STAFF REPORT

CONCERNING APPLICATION FOR A CERTIFICATE OF APPROPRIATENESS

Application Number: 2019-0329 Continued

Property Location: 1314 East Wayne Street

"Frame pulled away from house"

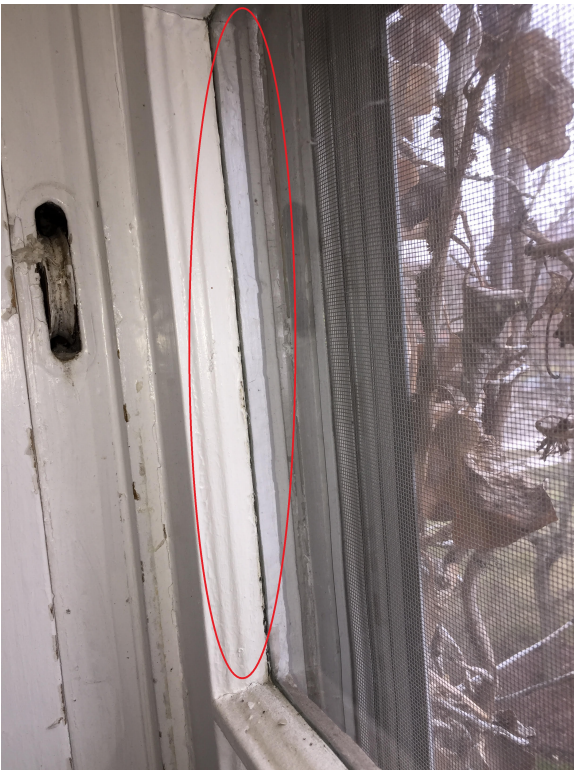
Owner has supplied the following description of the problems they are having: some of the windows are warped and won't close, some of the windows have interior rot, there is water damage on the interior of some of the windows, some of them no longer open, and because of the misalignment caused by the above issues, the windows are very drafty. See email for additional information provided by owner.

From photographs provided by the owner and Renewal by Anderson, staff acknowledges visible peeling paint on the wood storm windows on the first story, some broken sash cords, intermittent glazing failure, and layers of paint
